REVISED

ENVIRONMENTAL IMPACT STATEMENT  
PANIAU  
LALAMILO, SOUTH KOHALA, HAWAII

PANIAU  
LALAMILO, SOUTH KOHALA, HAWAII

Proposed Project: PANIAU  
Applicant: KEP ALULI, INC.  
Approving Agency: PLANNING DEPARTMENT  
COUNTY OF HAWAII

Figure 2  
Proposed Site Plan

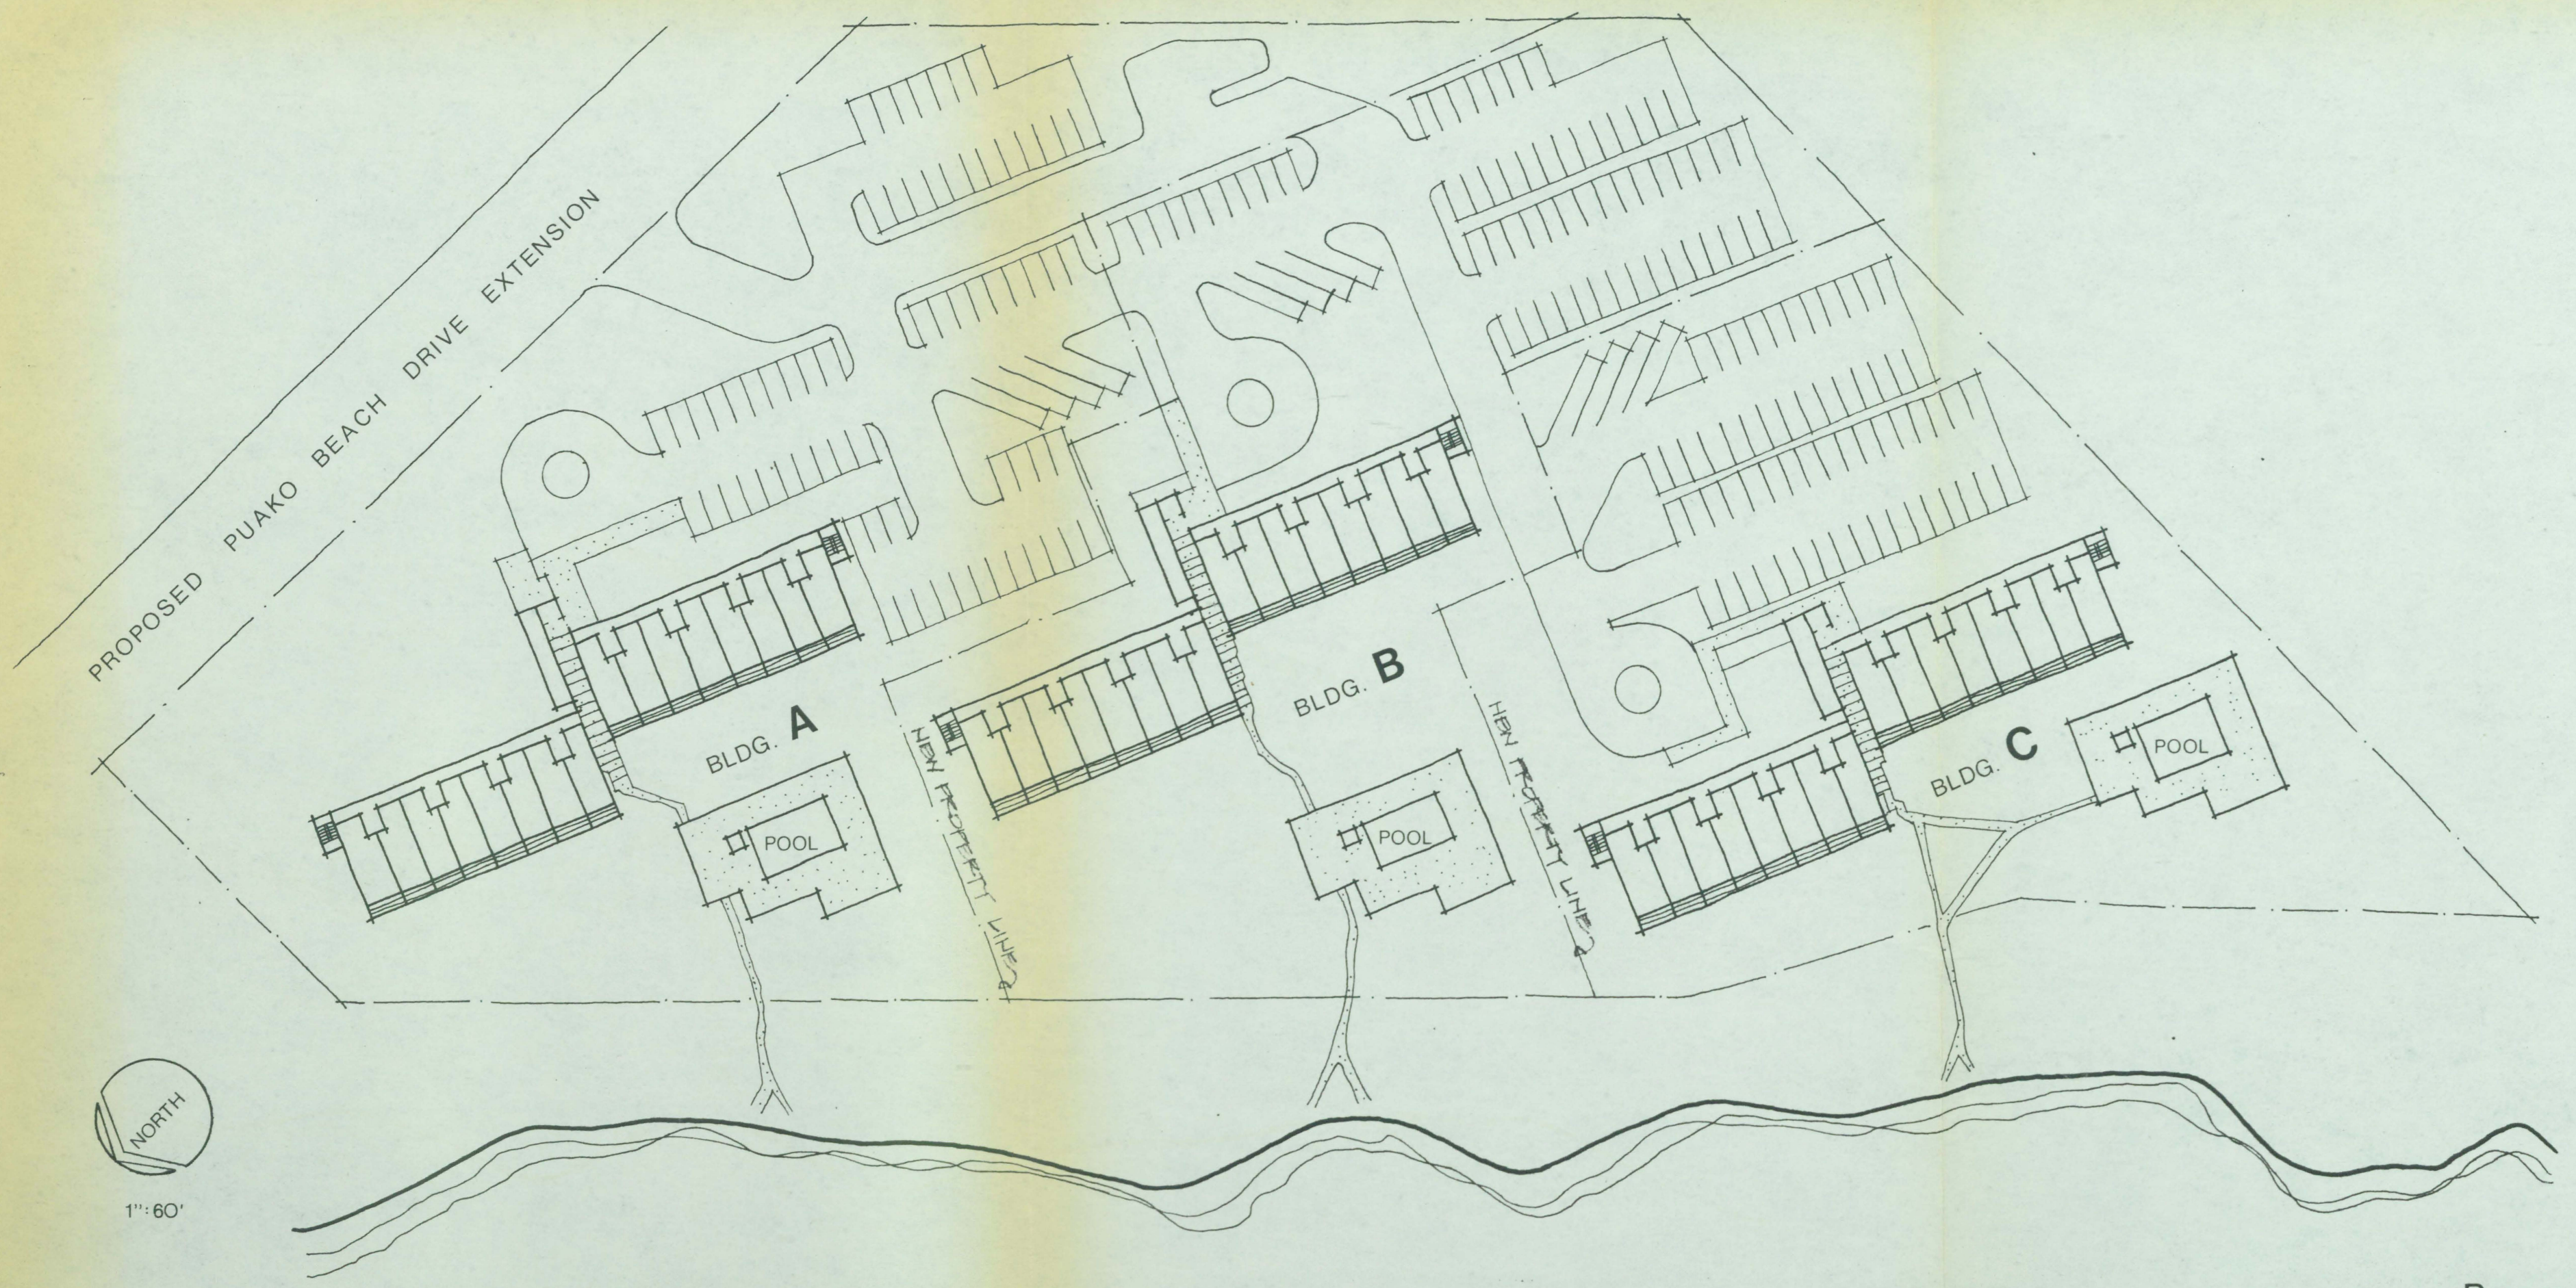
3. The EIS should include a site plan locating the archaeological sites superimposed by the proposed building and parking layout.
4. In calculating water demand requirements, the figure of 200 gallons/bedroom/day was used to estimate demand at 38,400 gpd. Please be advised that the Department of Water Supply

1. Access. The site plan indicates access to an extension of Puako Drive. This extension is yet to be built. Moreover, it is located on State land, and approval of the extension by the Board of Land and Natural Resources is needed before the extension can be constructed.
2. Sewage Disposal. According to the EIS, treated sewage will be discharged "underground" (p. 4). However, the subject parcel is close to the sea in an area where shoreline seepage is sufficient to produce an extensive layer of freshwater on the surface of nearshore ocean waters (p. 7). Since the substratum is so porous (p. 7), the treated effluent may be expected to appear at the ocean surface at and adjacent to the proposed project. The effluent would surface, since "most domestic wastewaters have densities lower than that of sea" (*sic*, p. 36).

It is also possible that the buildings may be sited differently than depicted in Figure 2 of the EIS. An alternative site plan would be based on the location of archaeological sites to be preserved, maintaining of existing anchialine pools or the location of a replacement habit (if this option is indeed the "best" solution), and composition of the underlying geological strata.
